PLANNING COMMISSION STAFF REPORT TYPE III APPLICATION

DATE OF MEETING:	July 28, 2025
FILE NO.:	25-037 DR_VAR
PROJECT NAME:	Basketball Court Shelter Variances
APPLICANT/OWNER:	Tiana Rundell/City of Sandy
ADDRESS:	18200 Meadow Drive/Deer Pointe Park
MAP/TAX LOT:	25E18CC 13400 and 25E18CD 01600
SIZE OF PROPERTY:	3.16 acres
ZONING:	Parks and Open Space (POS)
STAFF CONTACT:	Patrick Depa, Senior Planner

(Figure 1)

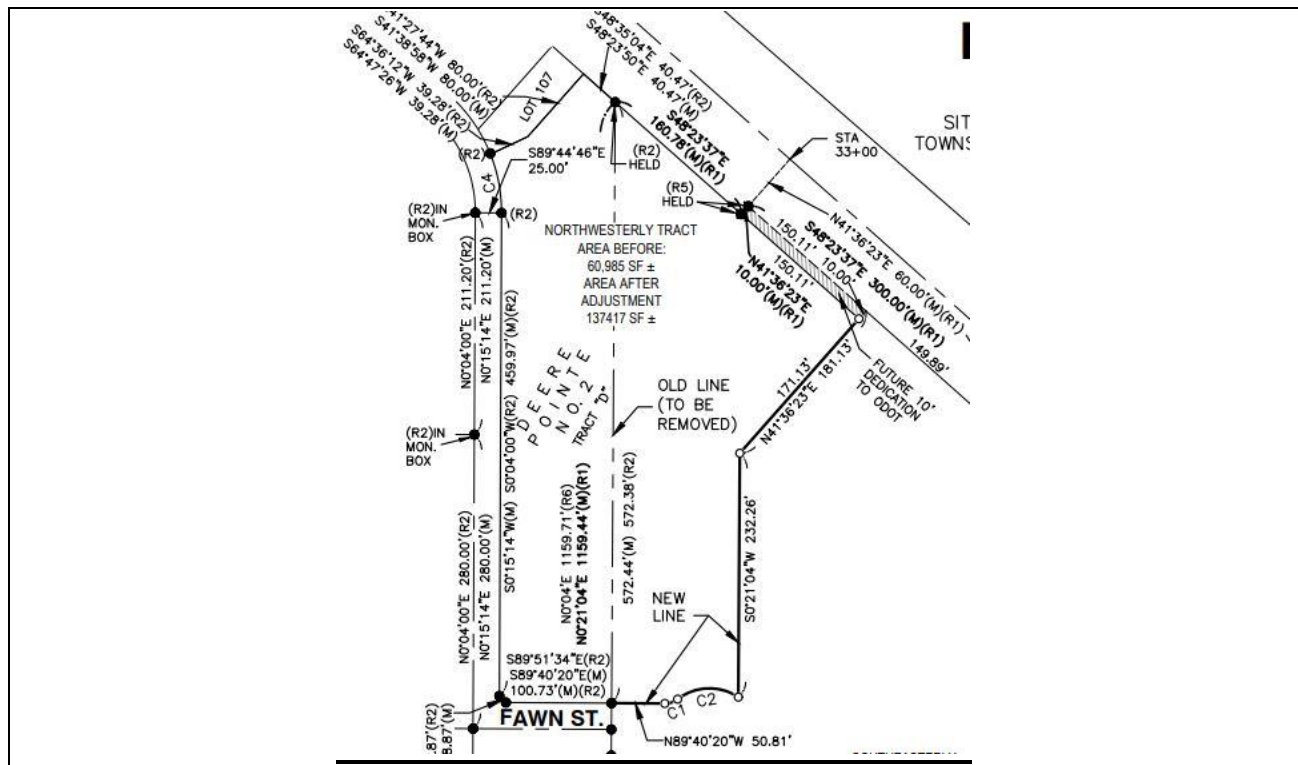
Finding 1. The placement of the basketball court crosses the common property line and several walkways meander between parcels to other park structures and amenities. The applicant submitted a Property Line Adjustment application (File No. 25-002 PLA) along with a draft survey to combine the two parcels. That application was approved with conditions by the Planning Division on February 26, 2025. **The applicant shall record the property line adjustment associated with File No. 25-002 PLA prior to issuance of the certificate of occupancy for the basketball shelter (see Figure 1).**

1. The applicant shall record the property line adjustment associated with File No. 25-002 PLA prior to the issuance of the certificate of occupancy for the basketball shelter.
2. The applicant shall apply for and receive approval for all necessary building permits prior to any construction. Contact the Building Division for submission requirements.

(Figure 2)

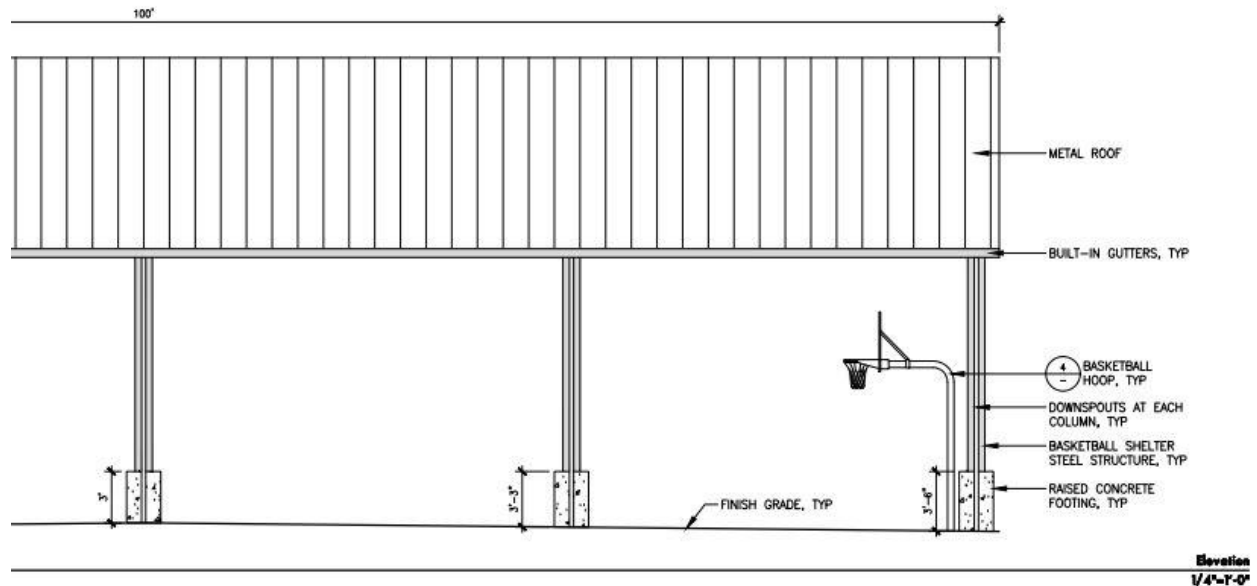
Finding 8. The basketball court shelter has a similar open-air design (no walls) as the proposed picnic shelter already approved for the park. However, where the picnic shelter has steel columns wrapped in stone that meet the above requirement to include strong base materials such as natural stone, split-faced rusticated concrete block, or brick, the basketball court shelter columns are not proposed to include such materials. The columns on the basketball court shelter are proposed to be steel but, will be set in a raised concrete base/footing (see Figure 2). **The exposed footings will be raised to show a 36-inch-high grey concrete base but without a stone wrap which will require a variance to Section 17.90.120.B.3.b. The applicant applied for a Type**

III Special Variance according to the process defined in Section 17.66.80. that will be addressed later in this document.

(Figure 3)

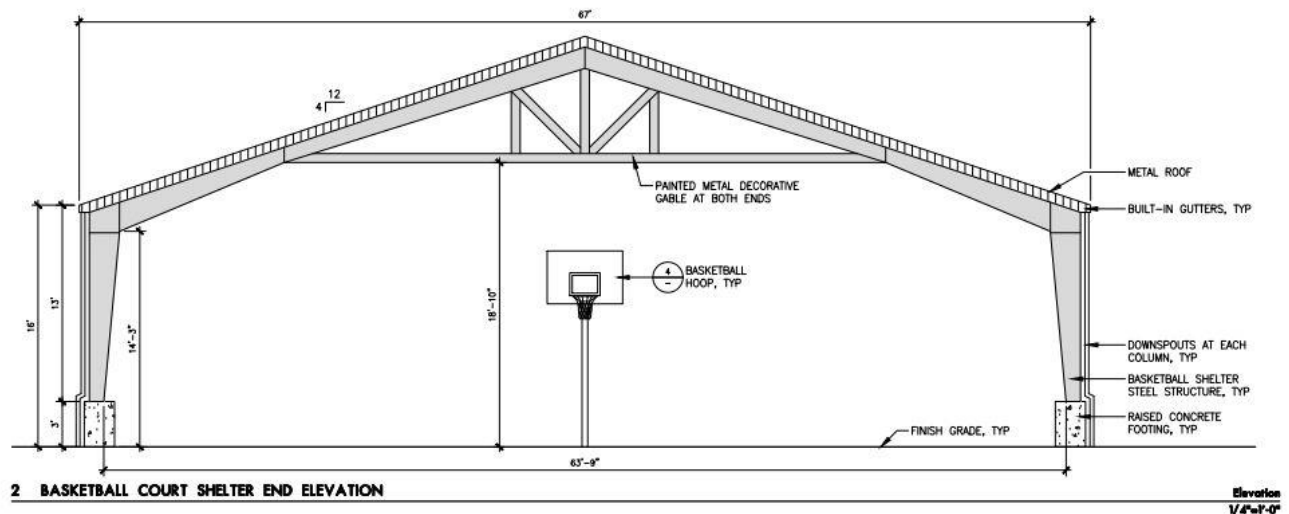
The open gable ends are comprised of painted metal decorative beams with a Howe style truss at both ends of the structure (see Figure 3). Neither gable ends face a street but both ends fall short of satisfying the requirement to include at least three “Sandy Style” design features. The materials used in the gable ends of the shelter can be modified to meet the requirements of this subsection and the number of design elements needed to meet the intent of this section.

The Planning Division is proposing as a condition of approval that **the applicant apply a dark base coat of paint on the exposed beams and brush on a different lighter color with a grain roller to achieve a wood style finish. Also, the Planning Division staff is recommending the installation of multiple heavy metal brackets at all connection points to replicate a Sandy Style design and finish. This is also emphasized under Finding 27.**
